New Bearing Carrier Design for All Compressors

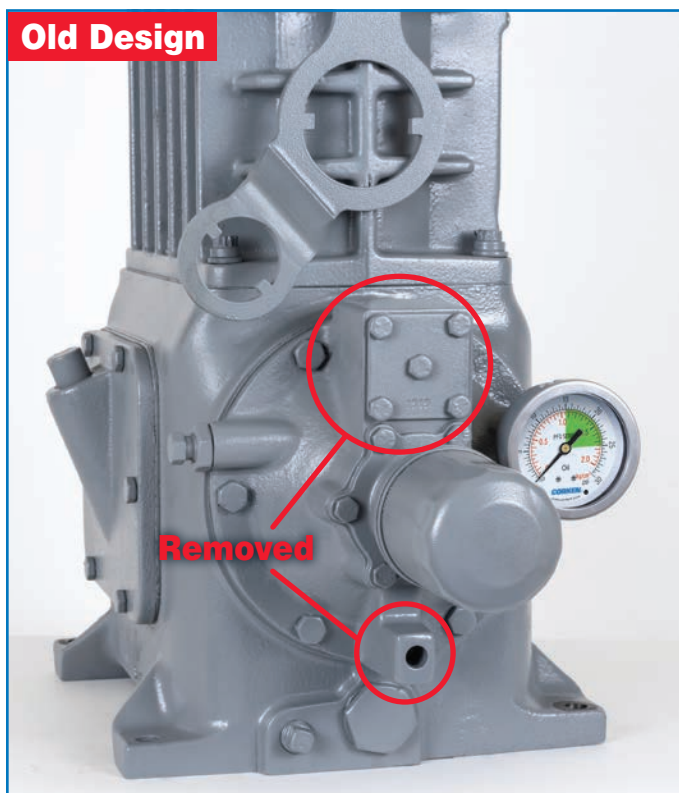
Corken has redesigned the bearing carrier for all compressors. The appearance of the bearing carrier has changed but the functionality has not. In the past compressors utilized air from the crankcase oil pressure to actuate the valve unloading mechanism. Since this is an older method and is rarely used, this functionality along with all nonessential areas/parts have been removed.

Current models utilize a solenoid valve allowing gas, nitrogen, or air to actuate the unloading mechanism. This method of actuation (a.k.a. Spec 9) has been in use for several years and is highly proven.
